# MAYOR AND COUNCIL AGENDA

**ACTION:** Discussion and Instruction on Planned Residential Unit (PRU) PRU2004-00021, Mid-City Urban, M.C.U., LLC, to redevelop the 65-Unit Lincoln Terrace Housing complex with 53 single-family attached units and 7 single-family detached units.

CITY OF ROCKVILLE PLANNING DIVISION  
STAFF REPORT

**Planned Residential Unit  
(PRU) application PRU2004-  
00021, Exploratory Plan**

# ATTACHMENT 2

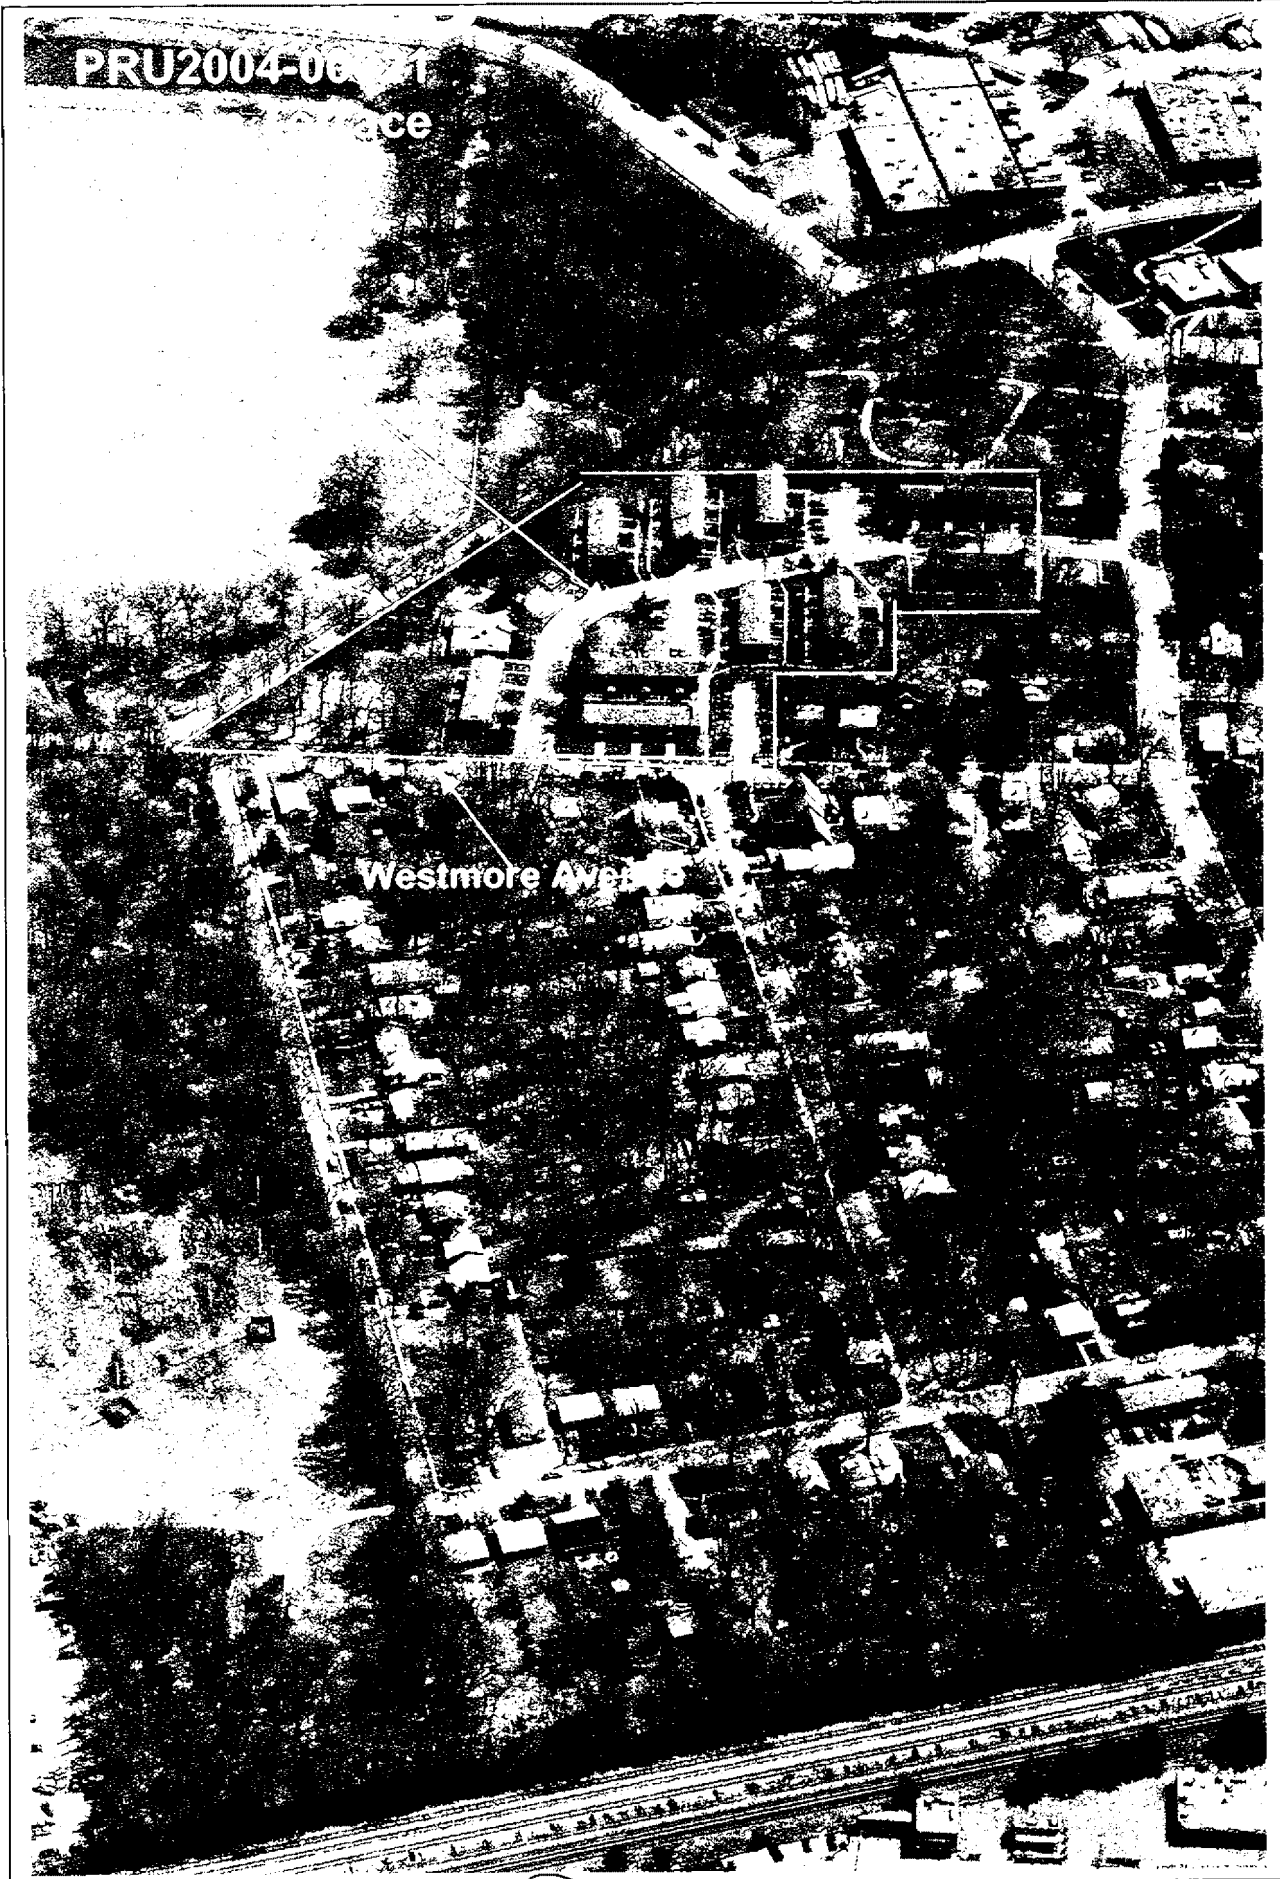
The first version of the plan presented to Staff showed a number of rear-loaded garage townhouses and units that fronted on Horners Lane. Horners Lane does not have curb and gutter, and the townhouses could not front on this road without significant cost to rebuild the road. In addition, the plan showed numerous private alleys and drives that would have to be maintained by a Homeowners Association (HOA). This plan also resulted in minimal tree preservation and left little room for landscaping, afforestation and street trees. The City tasked the applicant with revising the plan,

The second version of the plan presented to the City addressed the issue of frontage on Horners Lane and accommodated the park, resulting in increased tree preservation, and stormwater management facility. What it also did, however, was create more alleys and private drives, as well as twice as much infrastructure in the form of water and sewer lines that would require maintenance, and still left little room for tree planting.

The applicant and staff held a series of meetings to try and develop a solution that better addressed the balance of the previously stated goals. The result was a plan that had all of the townhouses fronting on Moore Drive with front-loaded garages. While accommodating the goals of reduced infrastructure and maintenance costs for the HOA, other issues were created, including an uninteresting streetscape, and a lack of street parking and inaccessible open space behind the units.

Staff has analyzed the proposed setbacks and requested height and feels that some changes should be made. While the applicant has not finalized the design of the units, staff finds that the side yards of the single-family houses are too small. Side yard setbacks of the proposed size are not conducive to proper maintenance within the side yards or the placing of air conditioning compressor units.

Staff realizes, however, that the number of units required for this site make larger lots and setbacks impractical. Therefore, staff recommends that the development standards reflect minimum setback standards for the single-family detached houses of four feet on the side. These setbacks reflect the minimum necessary to achieve a comfortable and functional design that is sensitive to the adjacent neighborhood, as well as respecting the constraints of the development area.

With respect to rear yard setbacks for the townhouses, staff feels it would be more appropriate to have a 10-foot rear yard setback in order to create a more comfortable space, in addition to allowing the appropriate placement of a deck or patio.

The height of the buildings is another area that staff feels should be amended. While the proposed neighborhood has site constraints, as well as the inability to provide "walk-out" or basement conditions because of topographical issues, it is staff's opinion that the heights be the same as the allowable height in the underlying zone, which is 35 feet.

Min Lot size	Front Setback	Side Yard setback	Rear Yard Setbacks
Single Family Detached	3,600 sq. ft	18' min (house and garage)**	4' min*	10' min
Townhouse	1,400 sq. ft	20' min	0' min*	10' min
Decks			4' (for single family detached, 0' for townhouses)	Within four feet of any rear lot line

\* There shall be no condenser units, heat pumps, etc., within the side yards

\*\* A single family house on a corner lot may have an 12-foot setback from Moore Drive, provided there are no driveways.
